Subject: Class 1 Permit Modification Notification to the Waste Isolation Pilot Plant Hazardous Waste Facility Permit Number: NM4890139088-TSDF

**Class 1 Permit Modification Notifications**

**Revise Attachment A4, Figure A4-2 to Add the New East Gate**

**Waste Isolation Pilot Plant  
Carlsbad, New Mexico**

**Figure A4-2  
WIPP Traffic Flow Diagram**

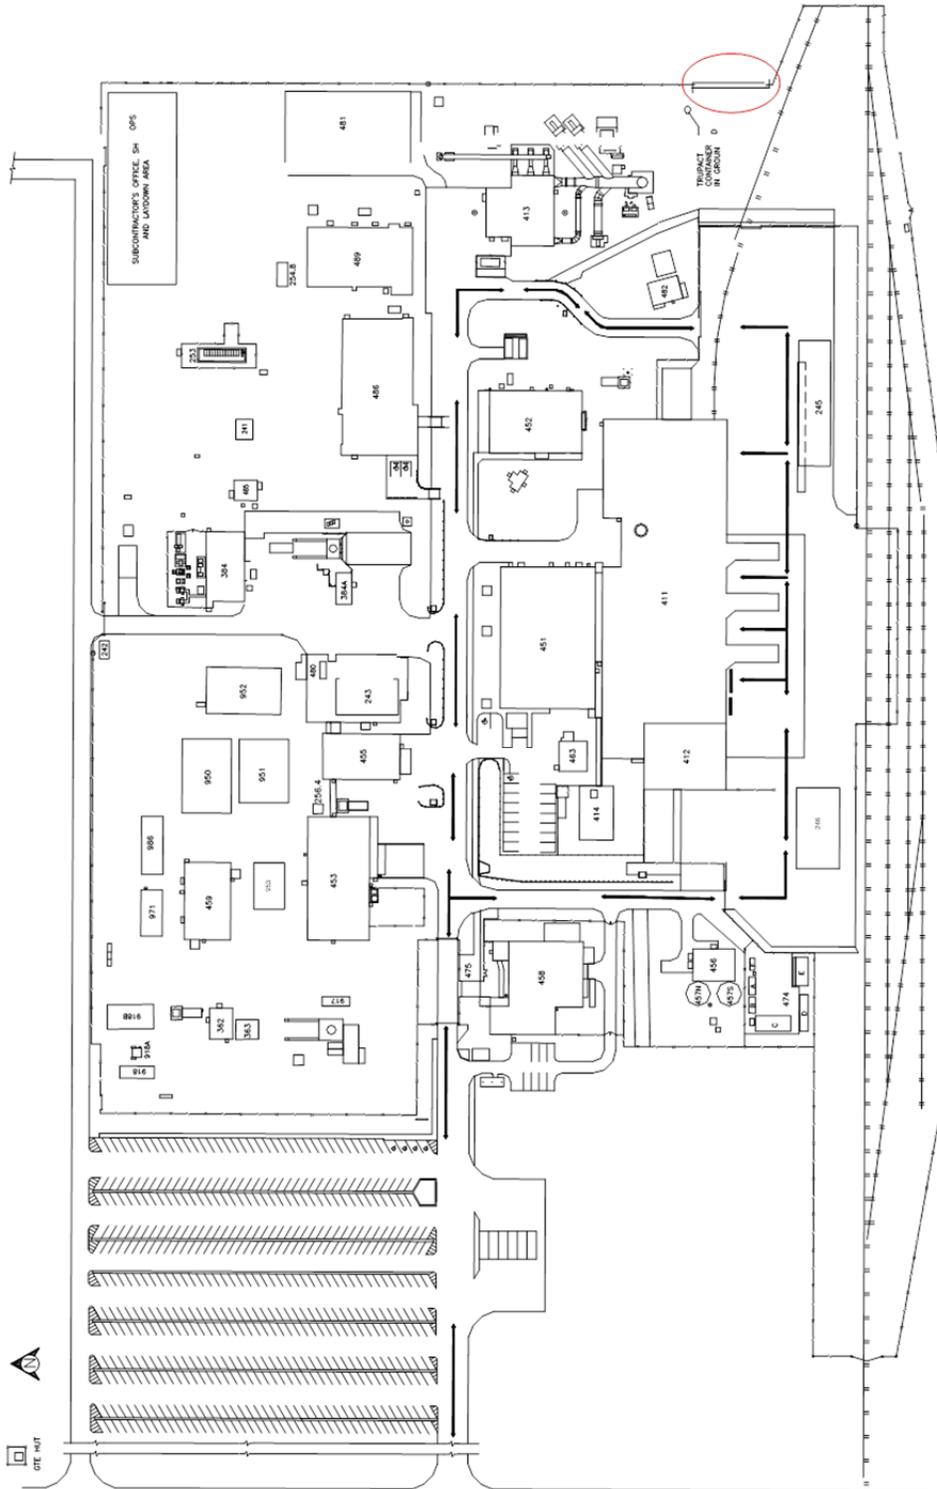
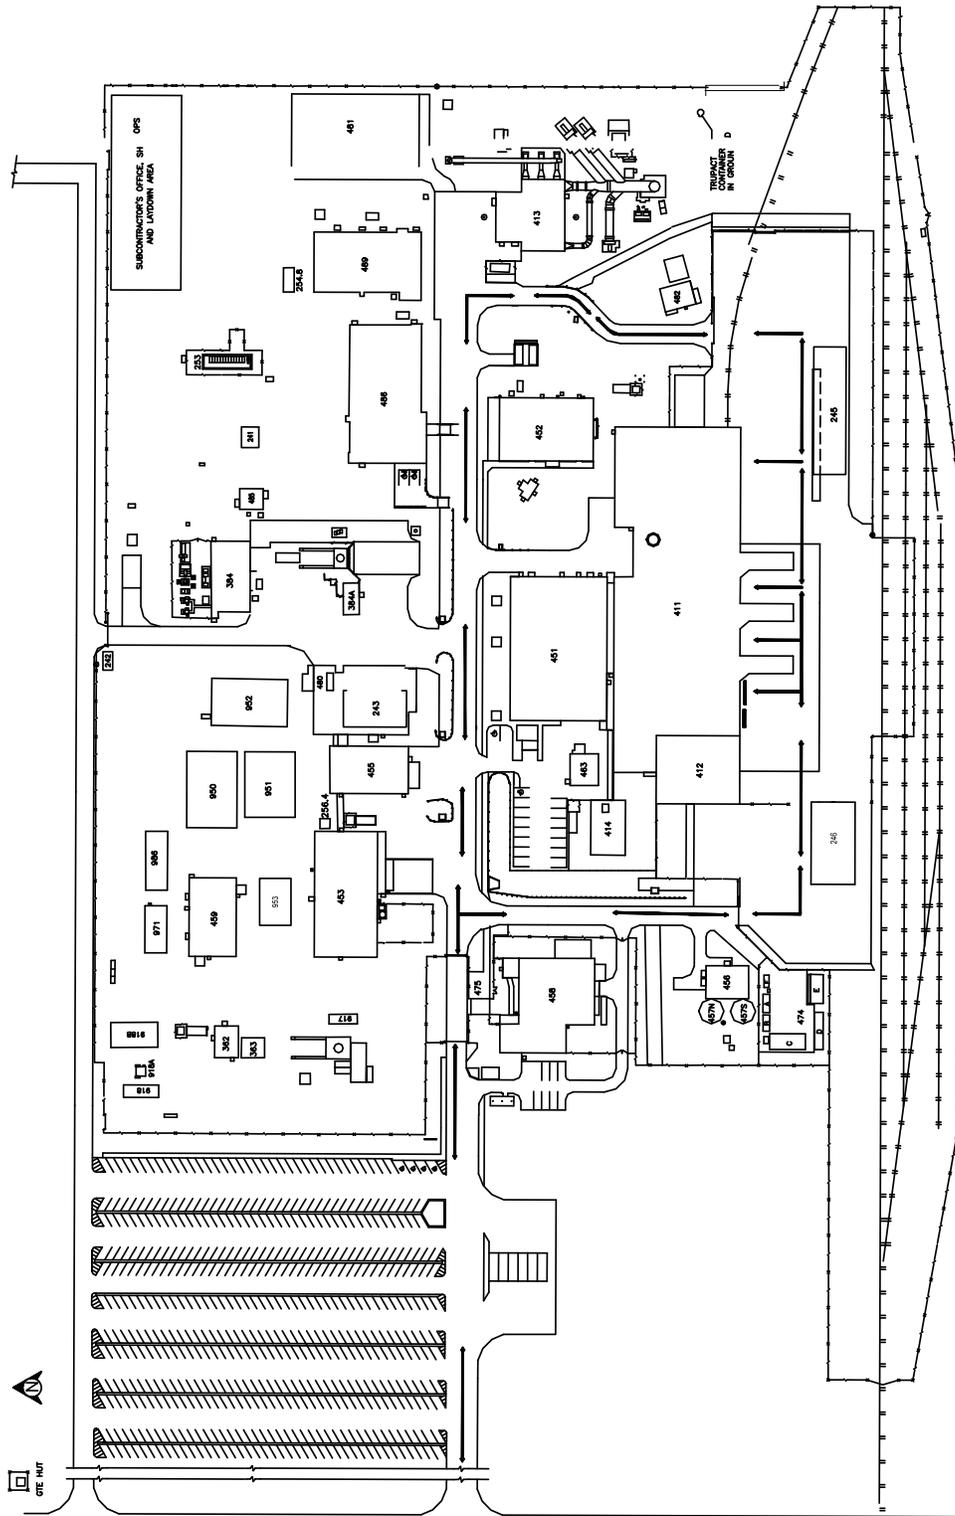
This modification updates Attachment A4, Figure A4-2 *WIPP Traffic Flow Diagram* to show the new east gate which is scheduled to be installed in the east fence line.

This change is needed to update the traffic flow diagram to accurately reflect the new east gate which will be used to allow delivery of large components and equipment for the new underground ventilation system. Other than the addition of the new east gate, there are no other changes to this figure. Other portions of the Permit related to fence security will remain in effect. This gate is not intended for waste handling activities. Updates to similar figures in Attachment D of the Permit will be made at a future date when the Attachment is revised.
